Independent Scientific Review Panel

2020 Response Review of the Hood River Production Program

Review of the Confederated Tribes of Warm Springs (CTWS) and Oregon Department of Fisheries and Wildlife (ODFW) response to the ISRP's review of the 2019 *Addendum to the 2008 Revised Master Plan for the Hood River Production Program (HRPP)*

ISRP 2020-2

Figure 2 (from the proponents' response). Hood River winter steelhead (1992 – 2013) recruits-per-spawner as a function of total available spawners.

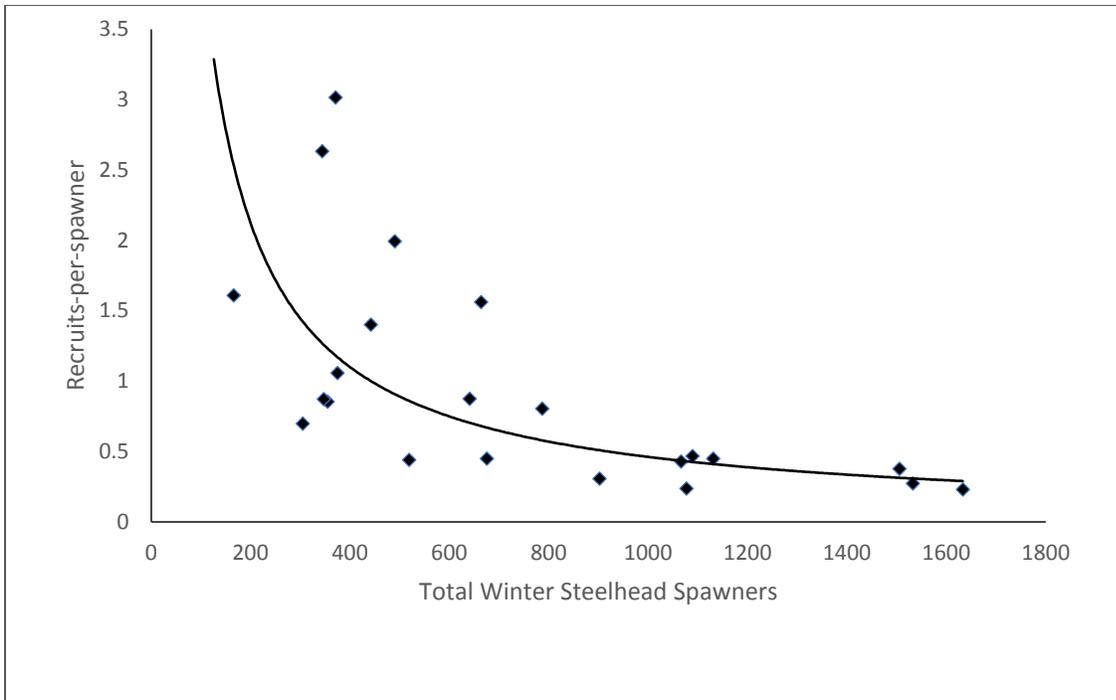
The ISRP has two specific concerns for how the provisional target of 1,100 NOS might be used inappropriately when managing returns of HOR. First, the goal of 1,100 NOS must not encourage managers to achieve a total escapement of 1,100 spawners by allowing a large escapement of HOS in the Hood River. The proponents note in their response that the ultimate goal is to exclude hatchery steelhead from the spawning grounds (i.e., pHOS = 0). It is important that fishery managers also recognize this goal and seek to limit pHOS via selective harvests, selective removal at weirs and ladders, and if need be, reduced hatchery production. The selective harvest target has not been achieved to date, even though sufficient HOR have been available for harvest. The inability to harvest HOR or remove them at traps and ladders has resulted in large total escapements (i.e., 698 to 1246) and highly variable pHOS (i.e., 1 to 82%) over the past 5 years (Addendum Table 10). This continuing high abundance of HOS is almost certainly reducing the productivity of NOS given the analysis shown in Figures 2 and 3.

The ISRP asks that a quantitative decision tree be developed based on the ideas presented in the response before observations call for such decisions. The key goals of the winter steelhead program are to provide in-river harvests (i.e., 876 hatchery steelhead), and to increase the number of NOS (i.e., 1,100 spawners) while maintaining the fitness of this primary ESA population. The harvest goal is not being met because fishing and trapping are inefficient—not because of insufficient HOR. Methods to increase harvest and trapping efficiency should be developed, evaluated, and implemented because increasing efficiency is the key to success. Meanwhile, the number of NOS has remained well below the target with no obvious upward trend (Figure 2).

The proponents also conclude that juvenile abundances (i.e., ranging from 78 to 1,828, 95% C.I. 48 to 2,238) and SAR values are typically too low for any model to characterize density effects. However, a low SAR value would not preclude a model from detecting density effects. Perhaps the proponents are simply pointing out that low levels of smolt production combined with low SAR values lead to "low" spawning escapements, but that conclusion begs the question of whether escapements are currently well below capacity. The ISRP's request to evaluate possible density effects on the productivity of spring Chinook is motivated by clear evidence of density effects on the productivity of the winter steelhead population. Data from the subbasin illustrate that recruits-per-spawner generally decreases when adult steelhead abundance exceeds ~400 fish (Figure 2).

Figure 3 (from the proponents' response). Density-dependent (Beverton-Holt) and density-independent stock-recruit models for Hood River winter steelhead (spawn years 1992 – 2013). Note the low number of steelhead recruits when the spawning stock exceeds ~800 fish.

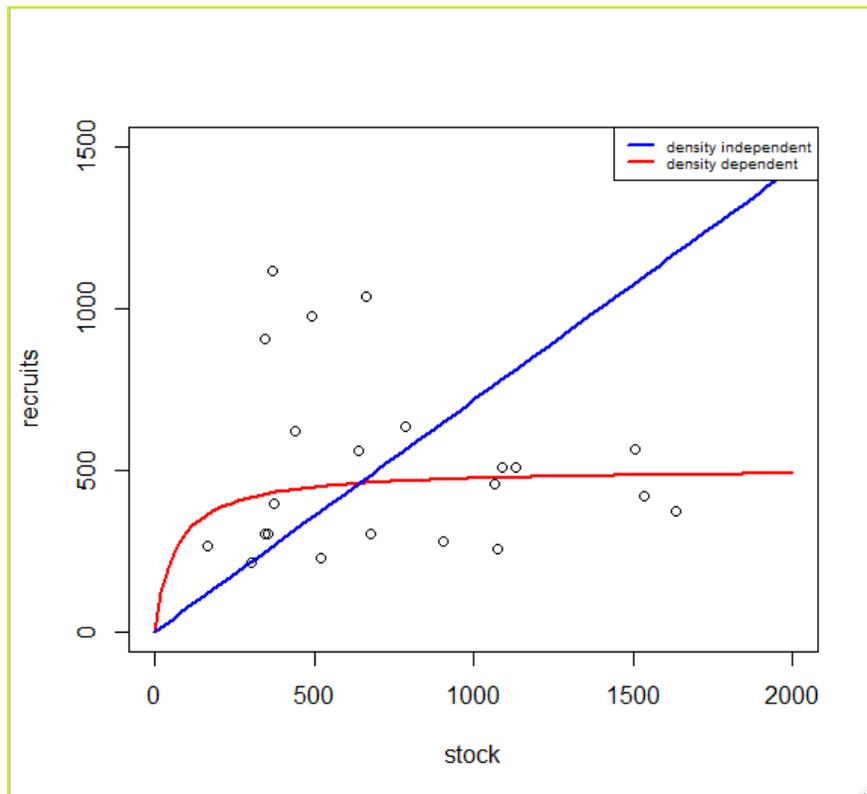
The proponents estimated “peak recruitment” (R_p) to be 504 spawners (95% CI 403-854). This terminology is a bit misleading because recruitment in some years clearly exceeded 505 adults. The parameter R_p is actually a measure of “average capacity” denoted by the asymptote representing

maximum average recruitment. The proponents did not calculate the number of natural origin spawners (NOS) needed for replacement (i.e., sustainable spawning abundance). Based on the BH parameters provided ($R_p = 504$, $a = 7.85$), the replacement spawning population would be 440 spawners (calculated as $R_p (1 - 1/a)$). Thus, the new stock-recruitment analysis seems to confirm that the best point estimate of sustainable spawning population is <500 spawners, as noted in our 2019 review based on data previously available.

The proponents assert that a spawning target of 1,100 natural origin spawners is appropriate, even though this target is higher than the estimated upper 95% CI for R_p for the 22-year time series. They make this assumption by pointing to uncertainty in the BH analysis, to observations that spawning habitat is greater in years of high flow, and to commentary by Quinn (2005). However, the proponents do not provide reasons to expect improvements in flow or other habitat conditions (see responses to qualifications WSP 1c and 1d). Quinn's commentary describes mechanisms causing density dependence and supports choosing a population model like the BH model that can capture the effects of density dependence. His commentary does not justify choosing a target beyond levels determined by a BH model. The ISRP agrees that increased flow and ongoing habitat restoration efforts could lead to greater capacity to support winter steelhead in the future than is indicated by the recent data series. However, the BH estimate already accounts for historical fluctuations in survival from flow and other factors.

Second, the plot of recruitment data in Figure 3 suggests “overcompensation” in that a spawning stock between 300 and 800 spawners produced the 6 highest recruitments and higher average recruitment than spawning stocks exceeding 800 spawners. The ISRP is not aware of any reports of overcompensation occurring in other steelhead populations, and the apparent relationship may be a statistical artifact of this 22-year time series. However, overcompensation has been reported in some Columbia River Chinook salmon (see [ISAB 2015-1](#) and addendum). The main concern arising from overcompensation is that recruitment is expected to decline (rather than just level off) at high spawning abundance. HOS will exacerbate any overcompensation effects on NOS, so selective removal of hatchery steelhead in the fishery and at traps and ladders is needed to prevent the HOS escapement from causing the total escapement (i.e., HOS +NOS) to exceed the putative overcompensation threshold (i.e., ~800 spawners).
